# Addendum

**PROJECT:** City of Springfield, Fire Station No. 5

## **ADDENDUM NO. 4**

**(C6) 118 DECOMPRESSION - EAST**  
3/8" = 1'-0"

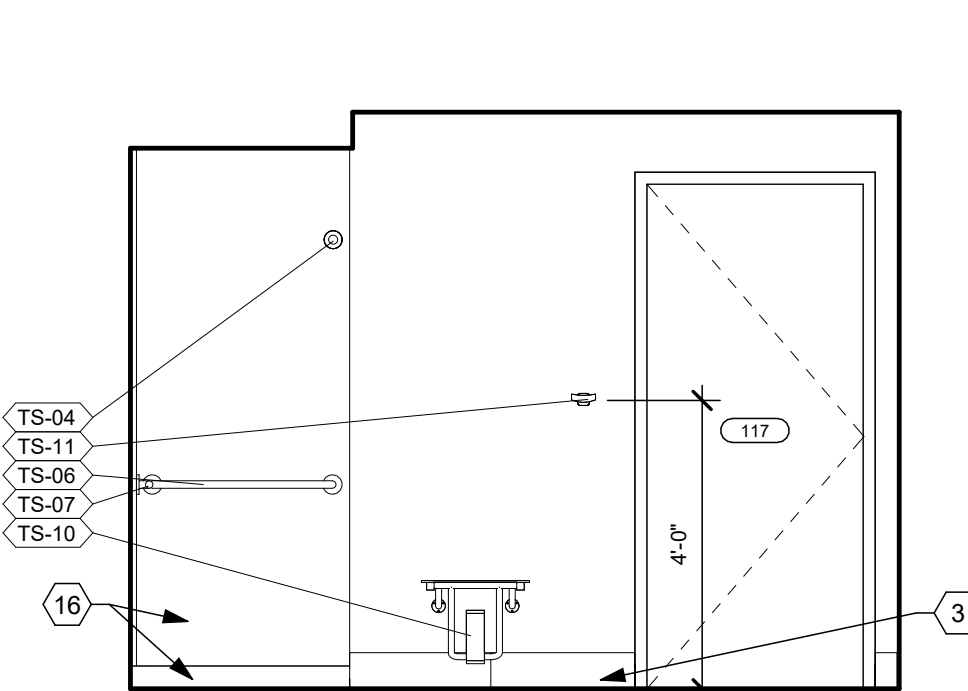
- ITEM A7 SHEET A5.01 – EXTERIOR DETAILS ROOF
1. Detail D4 revised to show liner panels.
- ITEM A8 SHEET A7.03 – INTERIOR ELEVATIONS
1. Added elevation C6 at 118 Decompression room.

TITLE **FIRST FLOOR PLAN**  
SHEET NO. **F1.1**

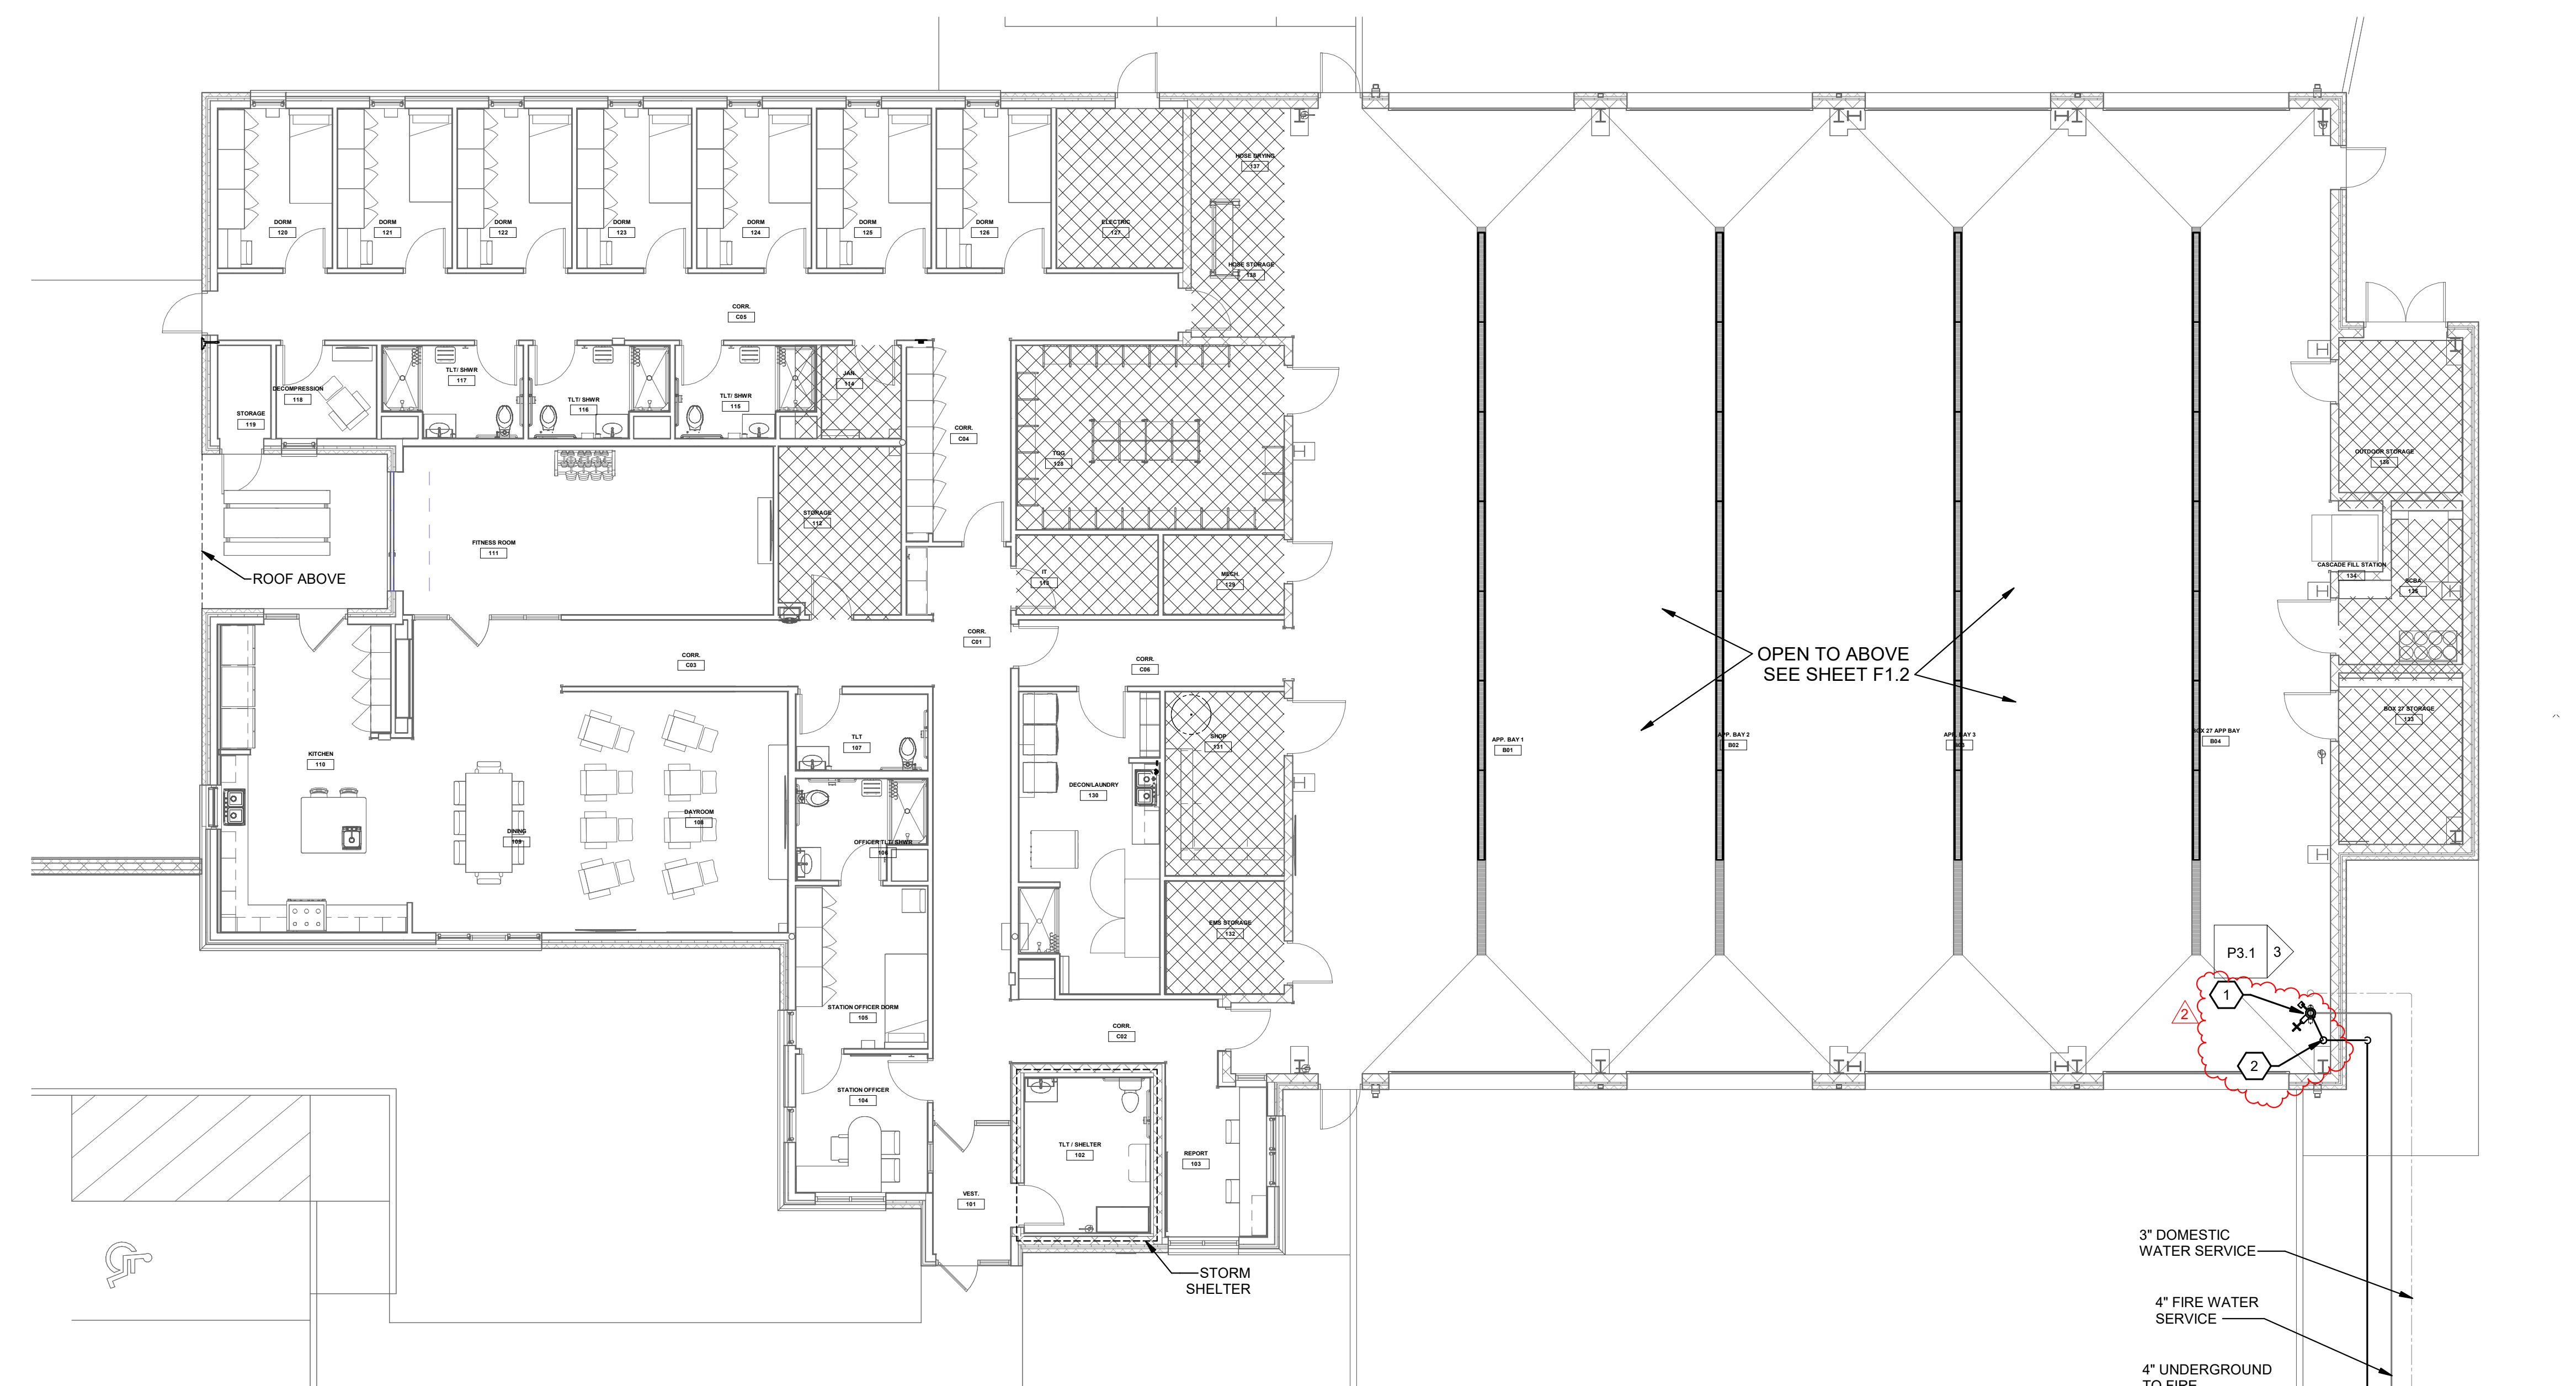
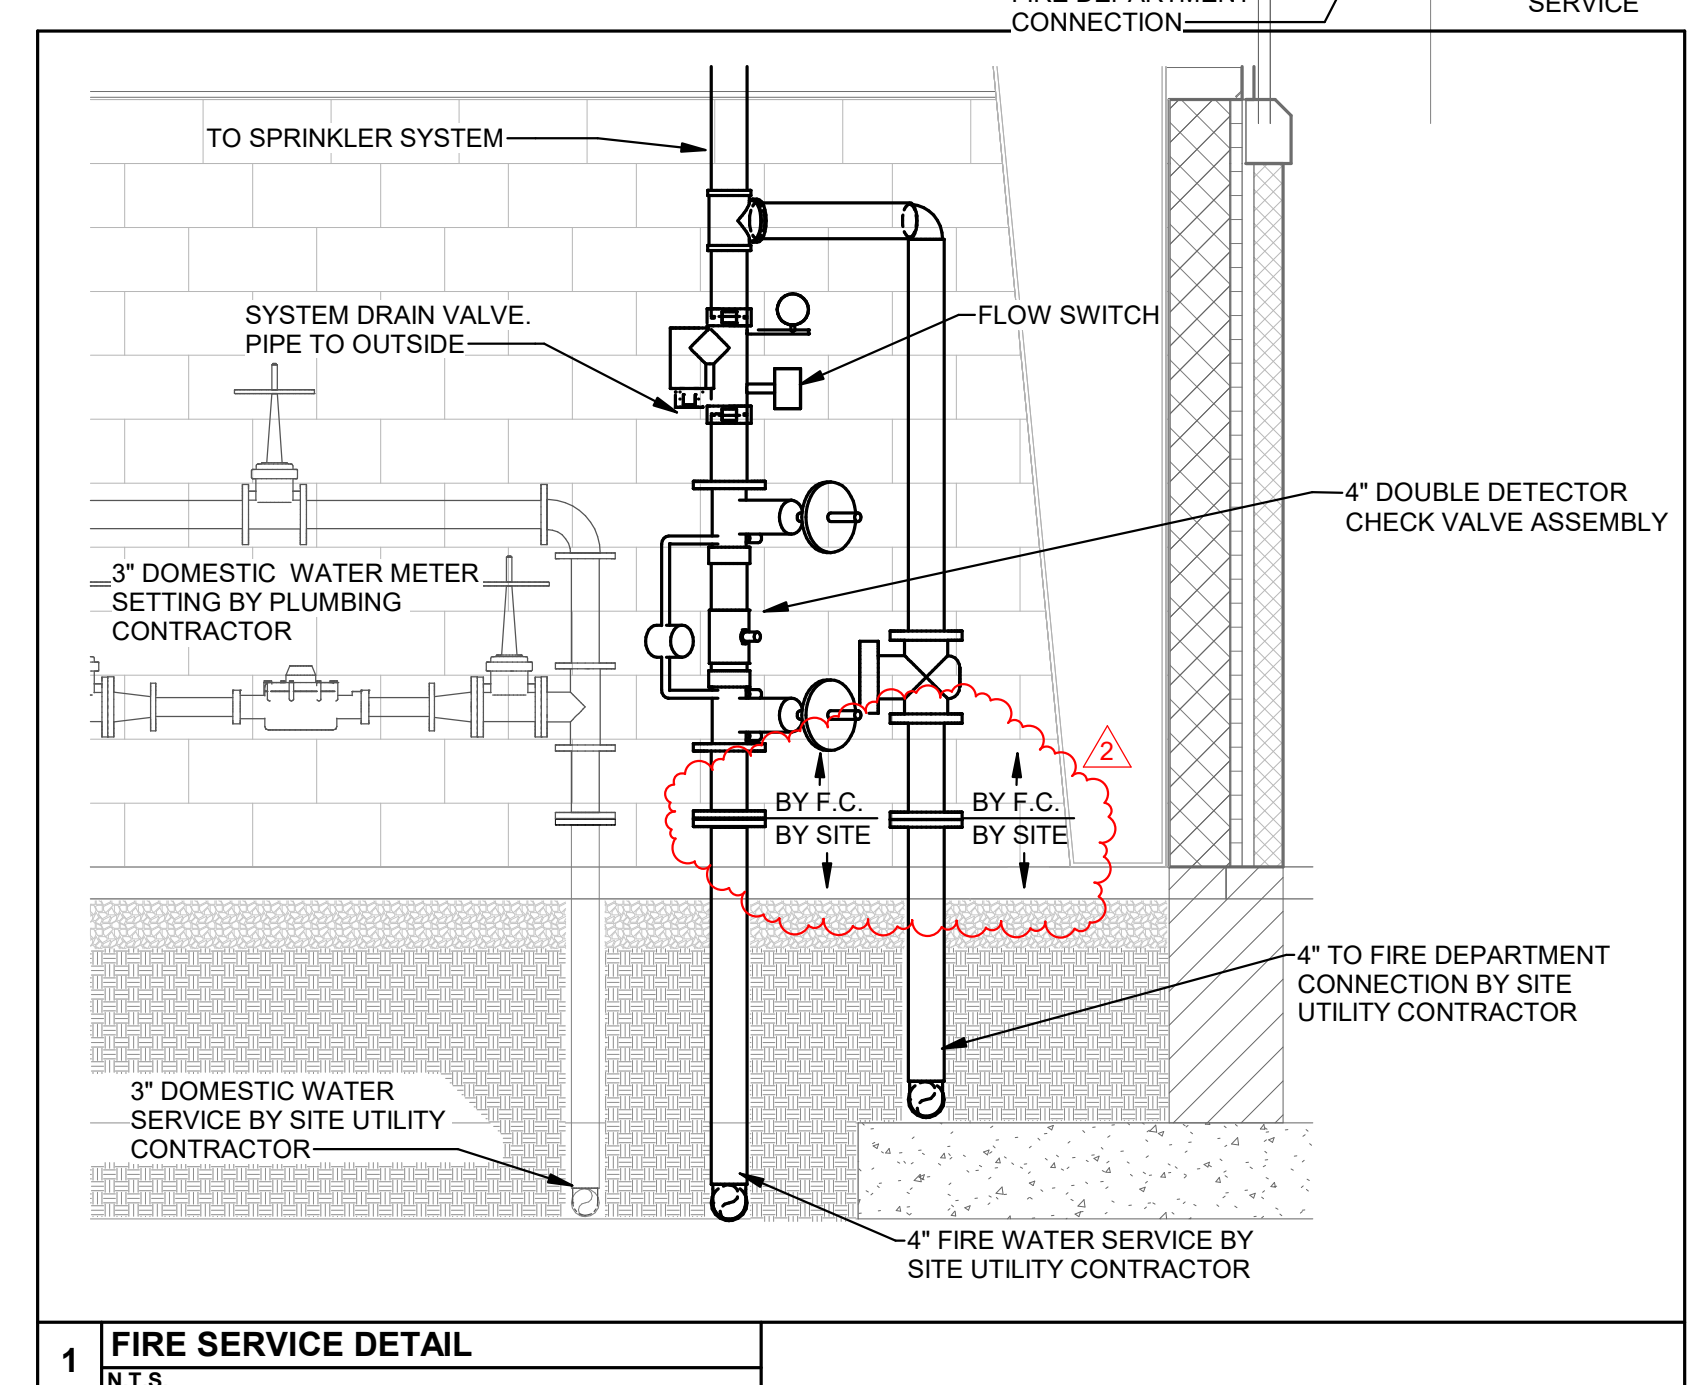
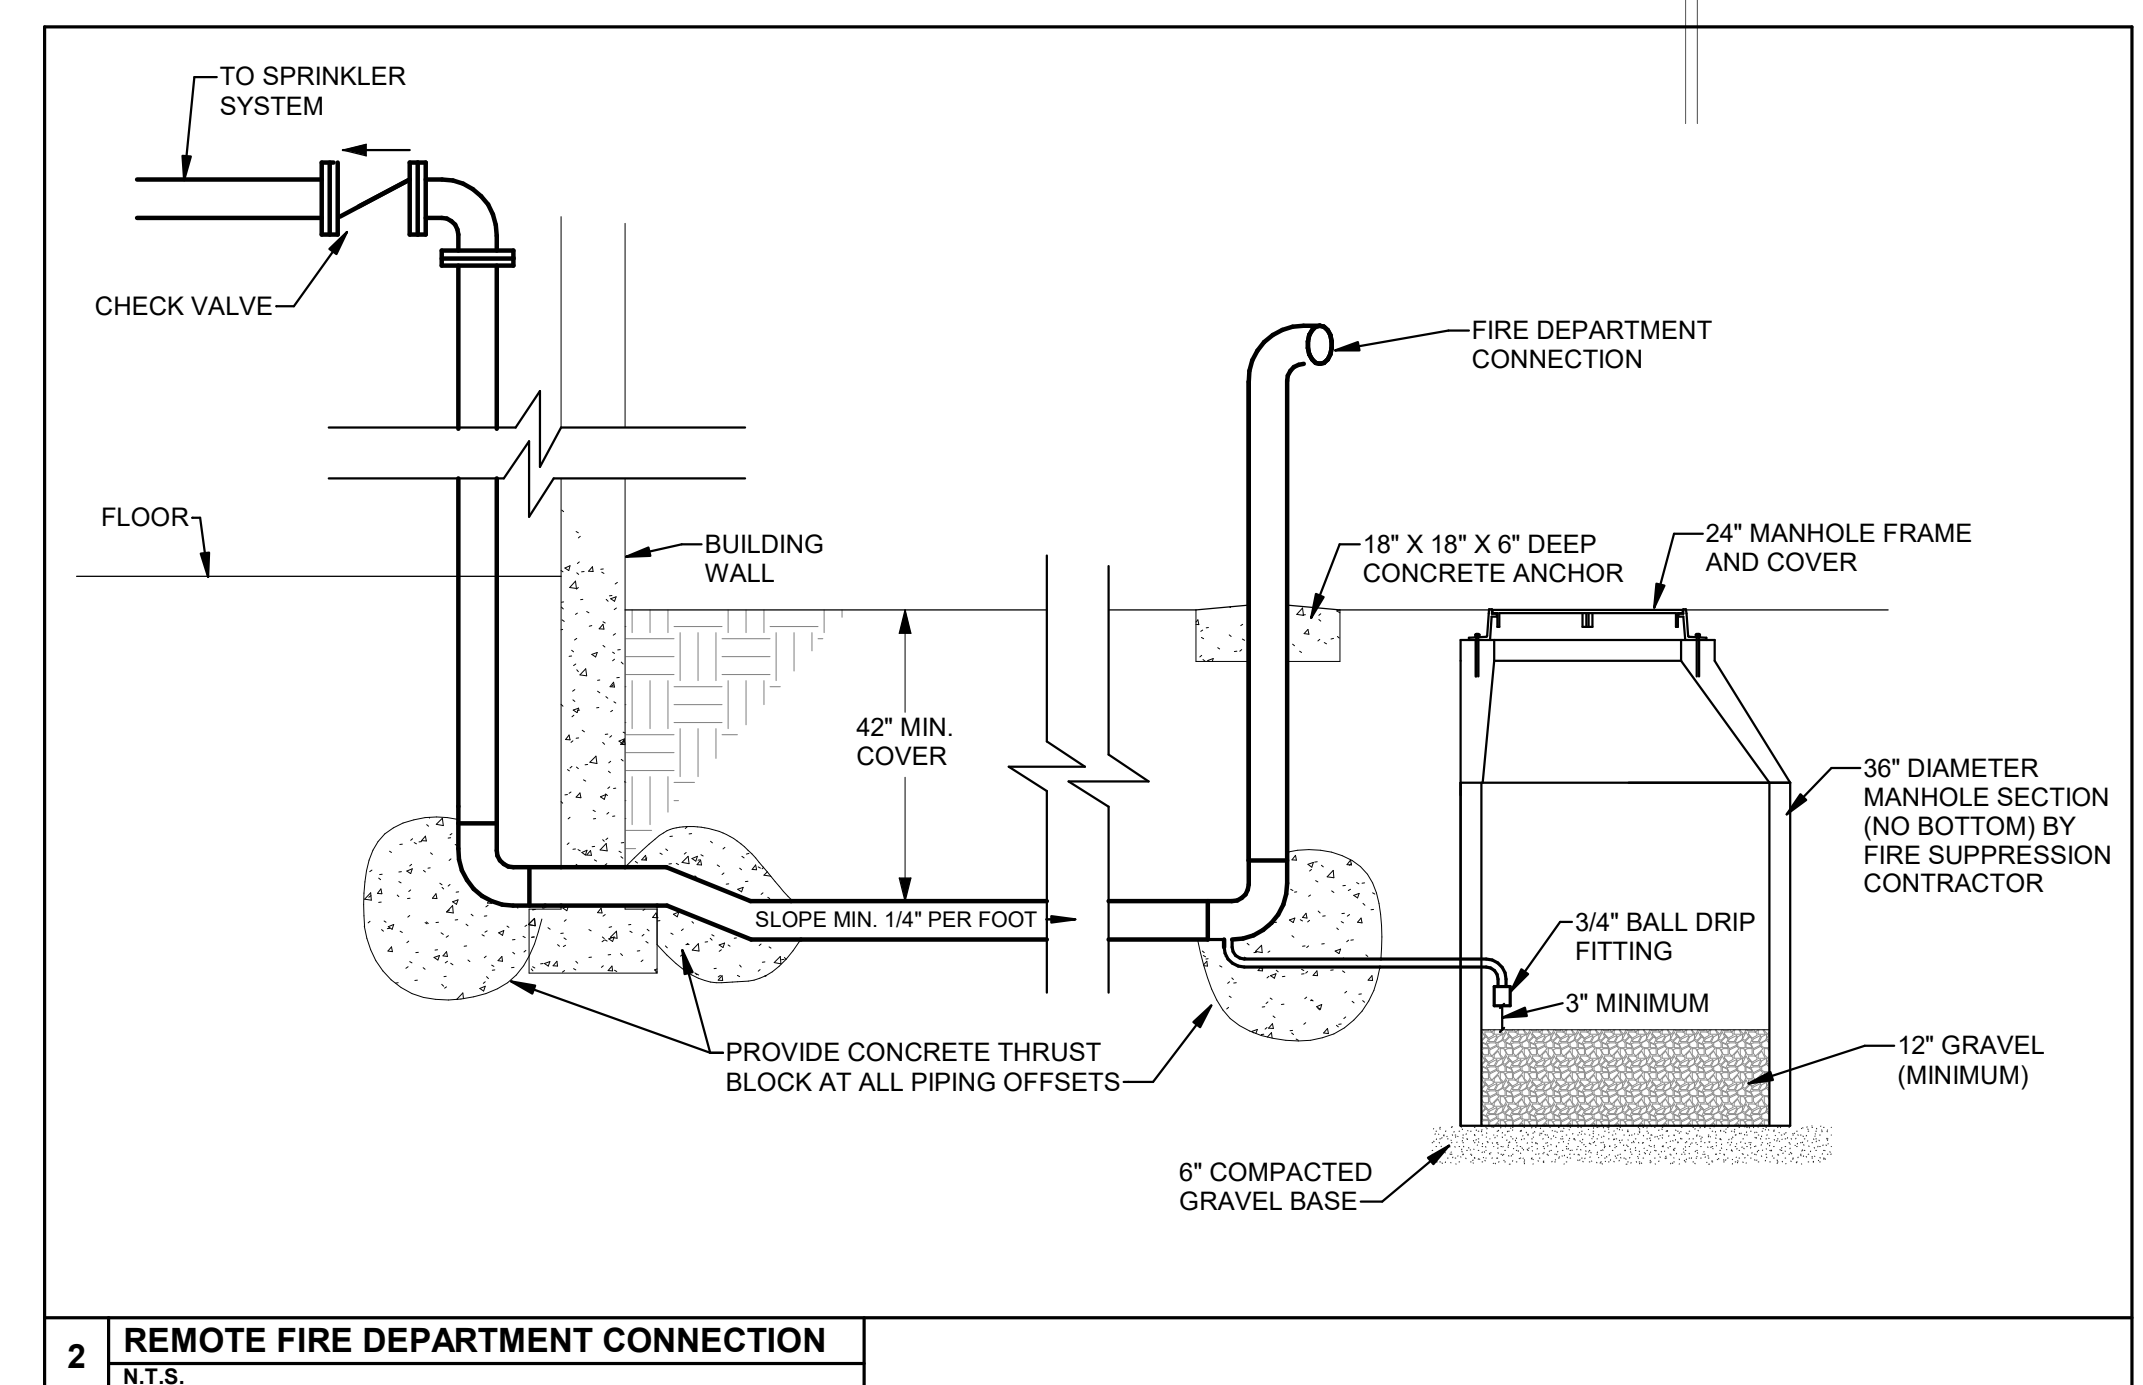
- Q7: I believe it stated that all utilities were brought in by others, but the 4" backflow would be furnished and installed per the fire contractor, correct? -Also on the backflow, is there a hotbox these items are going into or a pit, or inside? -remote Storz FDC or Siamese on the exterior of the building?

- ITEM F1 SHEET F1.1 – FIRST FLOOR PLAN
1. Corrected locations of construction notes 1 and 2 on plan.
  2. Clarified scope of work for site utility and fire suppression contractors on detail 1, F1.1.l.

The backflow preventer is in the vertical riser on the inside of the building as shown on the first-floor plan note 1 (the note is misplaced on the plan) and fire service detail on sheet F1.1 and is by the fire suppression contractor. The fire service detail is an interior elevation. The site utility contractor will bring the service into the building and turn it up. There is no pit or "hot box".

The site utility contractor will also run the underground piping from the remote Storz connection into the building as detailed on the remote fire department connection detail on sheet F1.1. They will again turn it up and provide a flanged connection. The Fire Suppression Contractor will connect to that and provide the check valve.
